Access Compliance Report

Public Rights-of-Way

Intersection ID: 31687	Main Street: GALLISON_AV	Cross Street: VALENDRA_DR	Location: NW
ADA ID: A40DBB14180D	Ramp Type: PerpDiag	Initial Pass/Fail: Fail	Overall Compliance: No
		Severity Score: 25

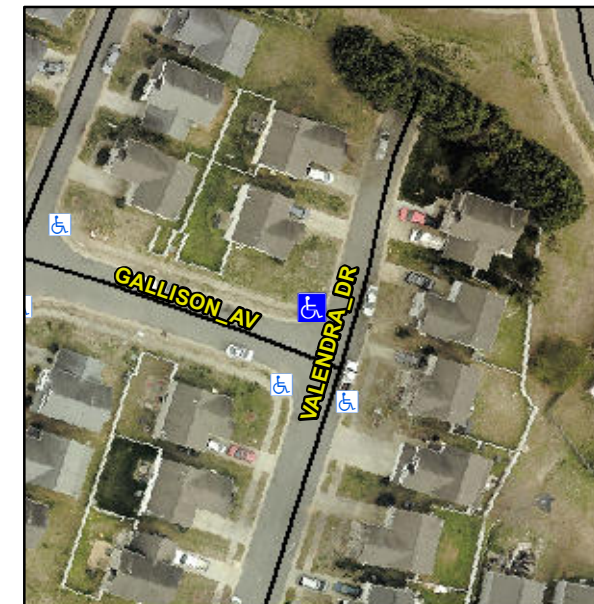
Compliance	Description	Data	Compliance	Description	Data
N/A	Ramp Length (in)	47.5	Yes	Ramp Slope (%)	5.4
Yes	Ramp Width (in)	56.0	No	Ramp XSlope (%)	8.6
N/A	Flare Type LT	N/A	N/A	Flare Type RT	N/A
N/A	Flare Slope LT (%)	N/A	N/A	Flare Slope RT (%)	N/A
N/A	Flare Traversable LT?	N/A	N/A	Flare Traversable RT?	N/A
N/A	Landing Length (in)	N/A	N/A	DWS Provided?	N/A
N/A	Landing Width (in)	N/A	N/A	DWS Contrast?	N/A
N/A	Landing Slope (%)	N/A	N/A	DWS Length (in)	N/A
N/A	Landing X Slope (%)	N/A	N/A	DWS Full Width?	N/A
N/A	Landing Curb? (Y/N)	N/A	N/A	DWS Offset (in)	N/A
N/A	Shared Landing?	N/A			
N/A	Gutter Ponding?	N/A	N/A	Gutter Slope (%)	N/A
N/A	Gutter Lip Ht (in)	N/A	N/A	Gutter X Slope (%)	N/A
N/A	Painted X Walk1?	No	N/A	Painted X Walk2?	No
	X Walk 1 Direction	To SW		X Walk 2 Direction	To SE
N/A	X Walk 1 Width (in)	N/A	N/A	X Walk 2 Width (in)	N/A
	X Walk 1 Slope (%)	2.4		X Walk 2 Slope (%)	1.0
	X Walk 1 X Slope (%)	1.3		X Walk 2 X Slope (%)	2.4

Remove & Replace Curb Ramp With Two New Directional Ramps or Equivalent.
